# Report and recommendations of the Environmental Protection Authority

Earl Grey Lithium Project

– inquiry under section 46 of the
Environmental Protection Act 1986
to amend Ministerial Statement 1118

Report 1697

Figure 4: Malleefowl Mound Exclusion Zones

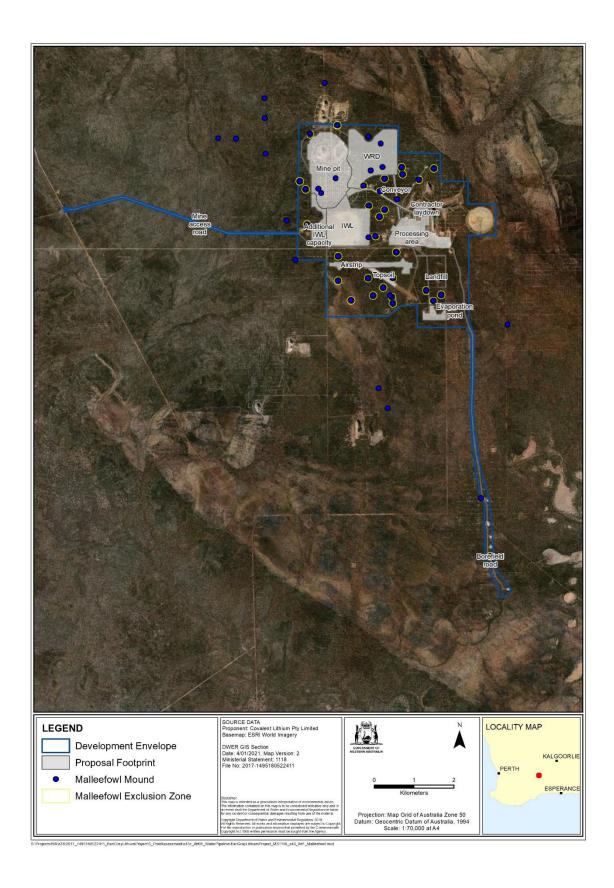
The proponent is seeking to remove one Malleefowl mound exclusion zone (MM23) from Schedule 2 of MS1118, to facilitate a change to the waste rock dump footprint. Previous conceptual layouts for the proposal sought to avoid the MM23 mound, however, following changes to mine design by the proponent, it has been identified that this avoidance would not result in an operable mine design and potential impacts to MM23 from indirect impacts may be unavoidable. Accordingly, the proponent is proposing to remove the MM23 mound, and the Malleefowl Mound

Exclusion Zone applying to MM23 from Figure 4 of Schedule 1 and Schedule 2 of MS 1118.

This mound was identified as active during the original assessment. The mound was used by a breeding pair of Malleefowl with activity observed between October and November 2019 by a trail camera. A feral cat was recorded at the mound (by trail camera) in December 2019 and no subsequent visits were made to the mound by Malleefowl. The eggs were likely to have been predated by the feral cat. The mound occurs in a fairly exposed location, with feral cats being recorded during the regional surveys, so it may not be a suitable long-term location for breeding success of Malleefowl.

Due to the current inactivity at the mound, it can correctly be defined as Inactive under the *National Malleefowl Recovery Team Procedures Manual* (NMRT 2019). The DBCA has also advised that they have no concerns with the reclassification of the mound to inactive and its removal from schedule 2 of MS1118.

The proponent has requested the removal of Malleefowl Mound MM23 and its exclusion zone from Figure 4 and Schedule 2 of MS 1118 referred to in Condition 7-1(1) and 7-1(3). The EPA considers it is appropriate to remove Malleefowl Mound MM23 from Figure 4 and Schedule 2 of MS1118 and amend Condition 7-1 to require the proponent to protect Malleefowl by controlling feral animals within the development area and within a three kilometre buffer surrounding the development area.

- While retaining the environmental requirements of the original conditions of Ministerial Statement 1118, it is appropriate to change Figure 4 and Schedule 2 referred to in condition 7-1(1) to remove reference to Malleefowl Mound MM23 and its exclusion zone, and add condition 7-1(4) to require the proponent to protect existing Malleefowl by controlling feral animals within the development area and within a three kilometre buffer surrounding the development area.
